BOCC CPA Hearing Meeting Date: November 13, 2025

Hillsborough
County Florida

1.0 APPLICATION SUMMARY

The applicant proposes to rezone a 15.32-acre property containing 6 parcels from AR (Agricultural - Rural), RSC-4 (MH) (Residential - Single-Family Conventional with Mobile Home Overlay) and CN (Commercial – Neighborhood) to PD 25-0703 (Planned Development) to allow for limited light industrial uses to include warehouse, wholesale distribution, open storage (accessory use only), and manufacturing/processing and assembly. This PD rezoning is accompanied by a companion Comprehensive Plan Amendment application HC/CPA 25-10, which is proposing to change the Future Land Use from Residential – 4 (RES-4) and Residential – 1 (RES-4) to Light Industrial Planned (LI-P).

8.0 PROPOSED SITE PLAN (FULL)

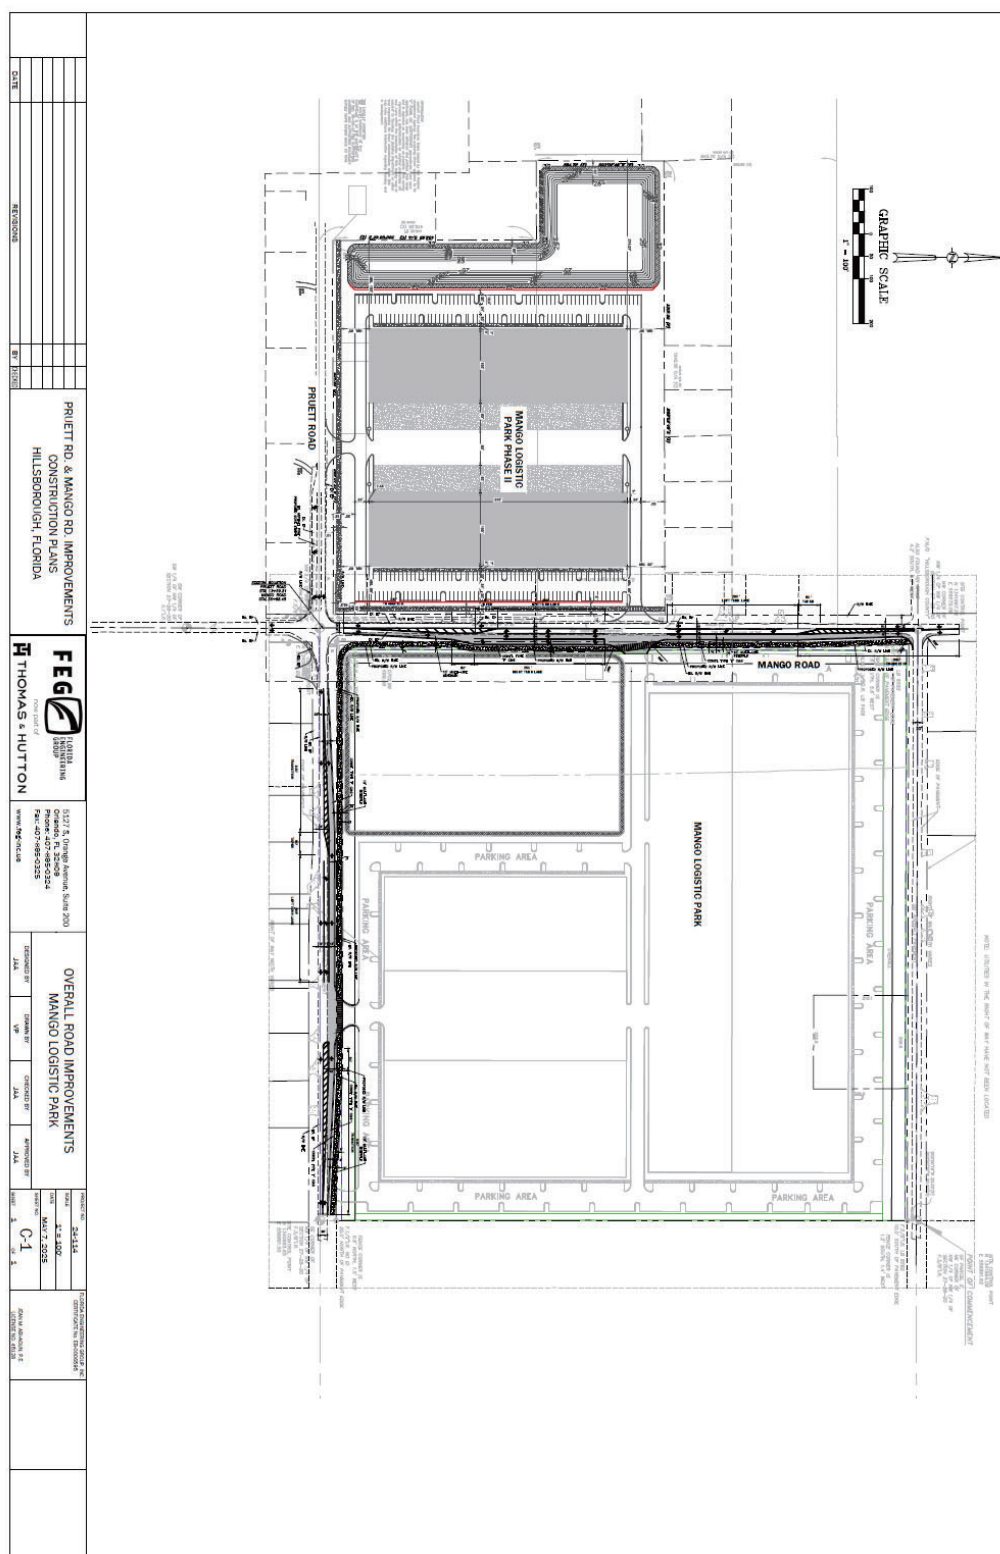
1. Revise the proposed F.A.R. to 0.285.
2. Revise current zoning to include CN (Commercial Neighborhood).
3. Add note about boundary wings: "The development shall include open storage screening boundary wings along the northern and southern boundary of the proposed buildings. Screening to extend minimum 100' from the street property line or entire depth of open storage area, whichever is less. Screening shall be required only if open storage is conducted. Screening shall consist of solid masonry walls, solid PVC fences, solid wooden fences at least 6-feet in height, or evergreen shrubs, at least 6' in height and 75 percent opaque and shall grow to form a continuous hedge."
4. Update Development Standards box to match the development standards in the proposed conditions.

Approval of the request, subject to the conditions listed, is based on the revised general site plan submitted August 26, 2025.

Figure 2: Typical Section

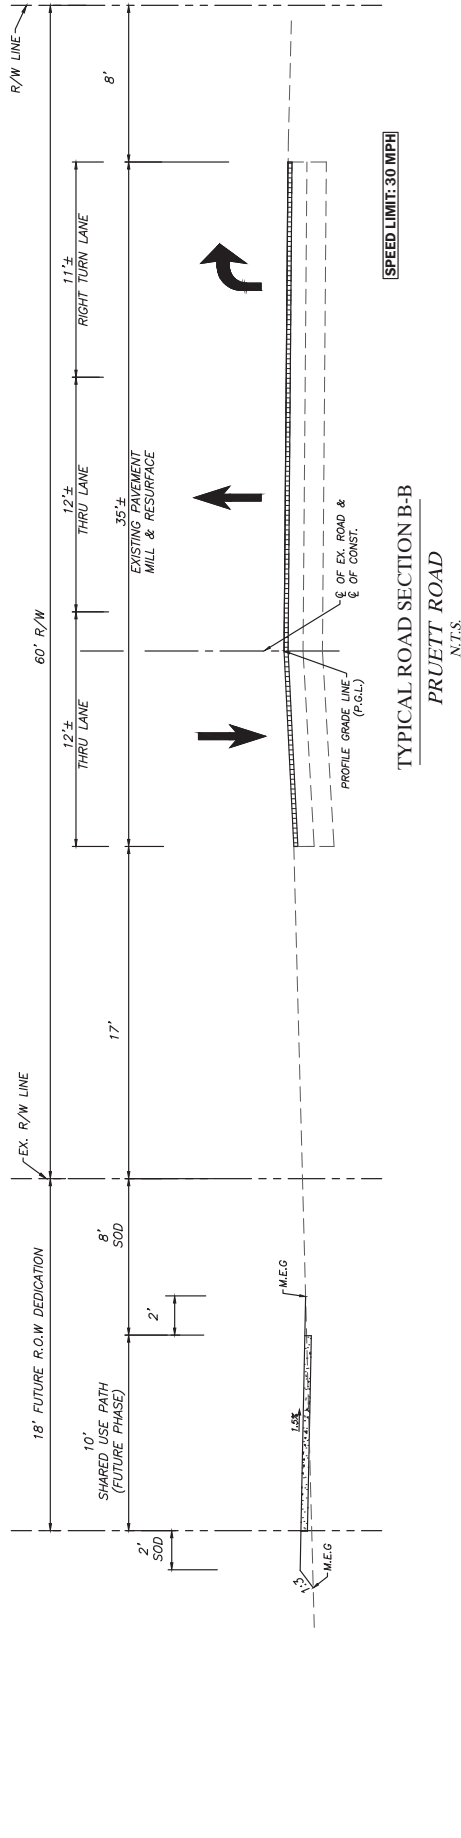
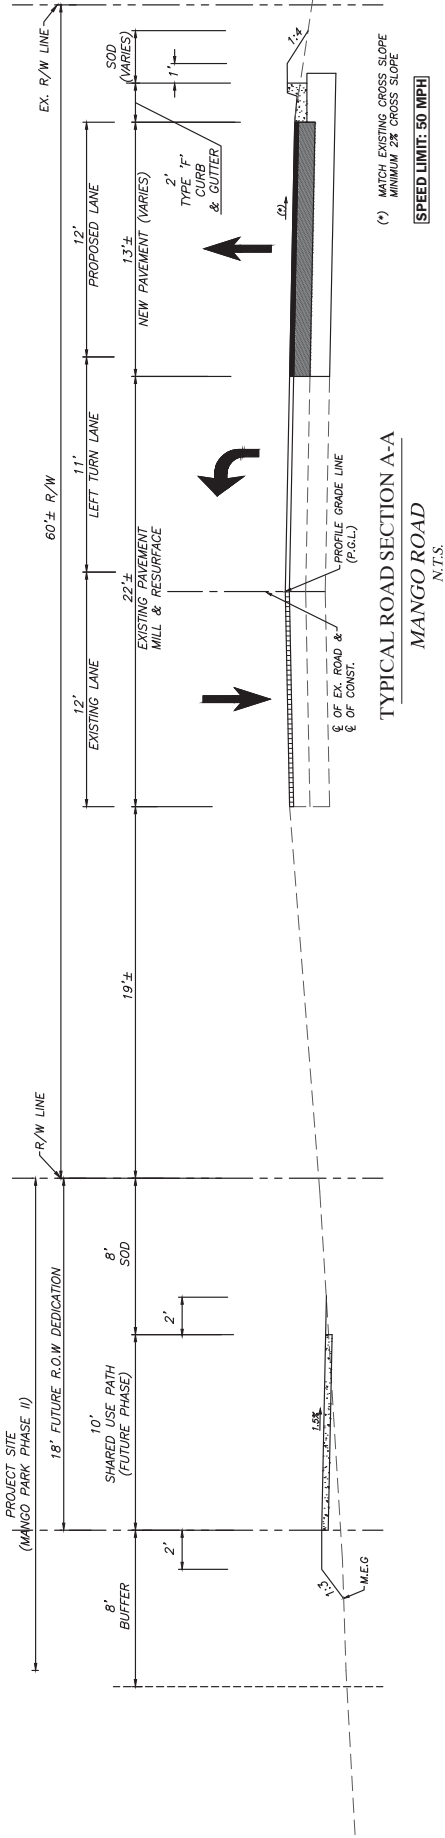
1. The existing ROW along Mago Road is approximately 60 feet. The typical TS-7 section for a local, two-lane undivided roadway requires a minimum of 96 feet of ROW with 12-foot lanes, 8-foot shoulders (5-foot paved), open ditch drainage and a 5-foot sidewalk. This section of Mango Road currently has 11-foot travel lanes, no bike lanes and a sidewalk along the west side of the roadway.
2. The request is to provide the 12-foot travel lanes and 11-foot auxiliary turn lanes with a F type curb on the east side of Mango Road.
3. Approximately 600 feet of 10-foot multi-use path will be provided only on the west side of Mango Road from Pruett Road to the northern property line. The multi-use path will be provided within an area to be dedicated ROW. There will be a 2-foot grassed area between the multi-use path and the new ROW line.
4. The ROW dedication area will be approximately 18 feet.

- a. widening the travel lanes to 12-feet,
 - b. provide 11-foot auxiliary lanes,
 - c. provide F-type curb on the east side of Mango Rd.,
 - d. construction of a 10- foot multi-use path along the Mango Rd frontage; and

TYPICAL SECTION

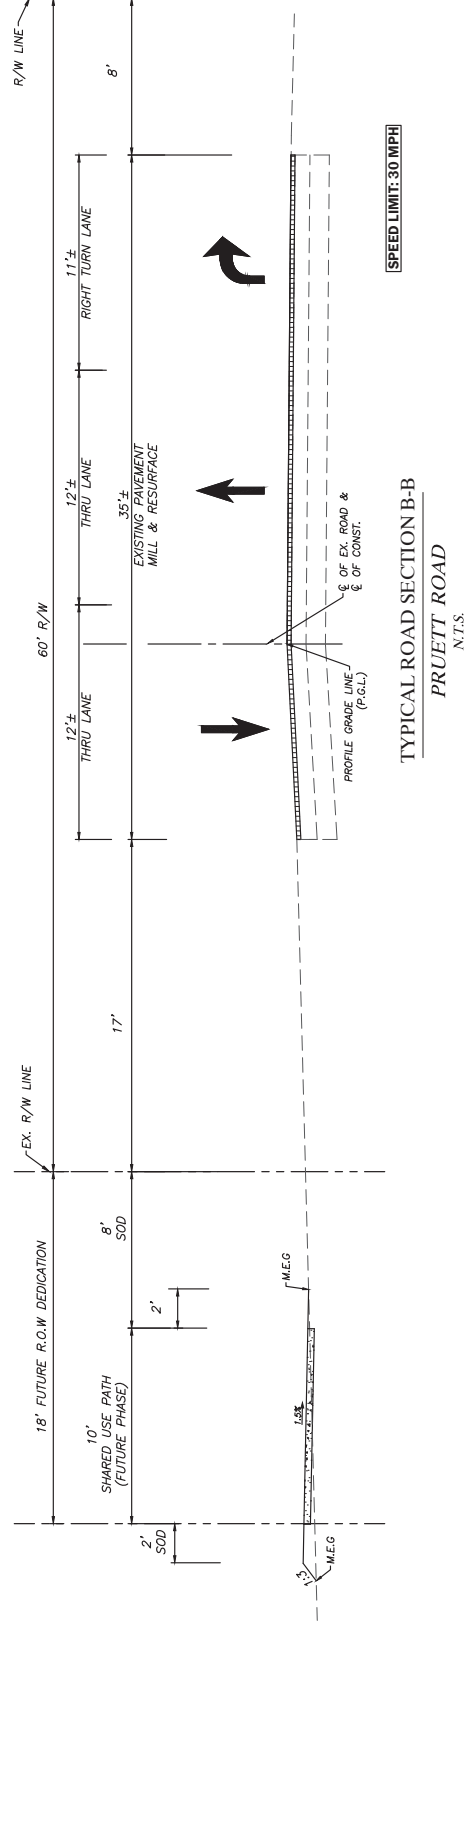
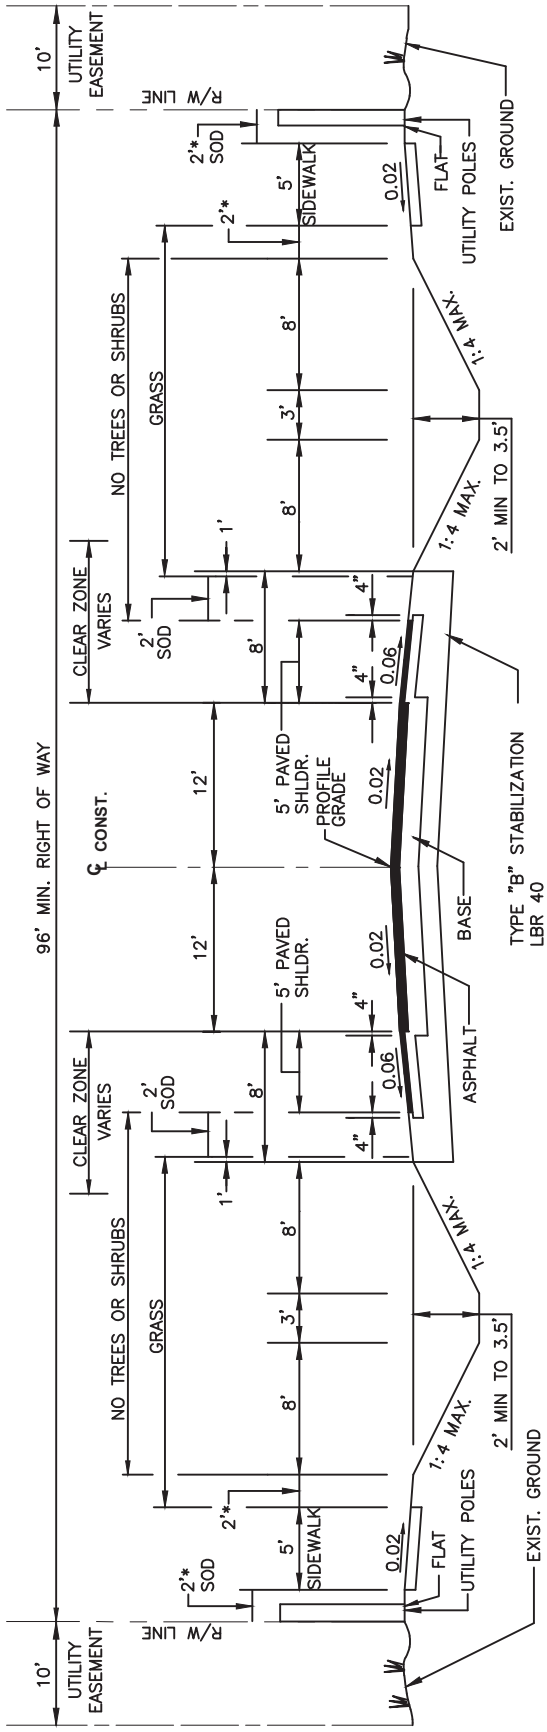
1. The existing ROW along Pruett Road is approximately 60 feet but does vary along the segment. The typical TS-7 section for a local, two-lane undivided roadway requires a minimum of 96 feet of ROW with 12-foot lanes, 8-foot shoulders (5-foot paved), open ditch drainage and a 5-foot sidewalk. This section of Pruett Road currently has 10-foot travel lanes and no bike lanes and no sidewalk.
2. The request is to provide the 12-foot travel lanes and 11-foot auxiliary turn lanes.
3. Approximately 800 feet of 10-foot multi-use path will be provided only on the north side of Pruett Road from Mango Road to the western property line. The multi-use path will be provided within an area to be dedicated ROW. There will be a 2-foot grassed area between the multi-use path and the new ROW line.
4. The ROW dedication area will be approximately 18 feet.

5. No modification to the south edge of the pavement, as all improvements will be made on the north side of Pruet Road.

- a. widening the travel lanes to 12-feet,
 - b. provide 11-foot auxiliary lanes,
 - c. construction of a 10- foot multi-use path along the Pruett Rd frontage, and
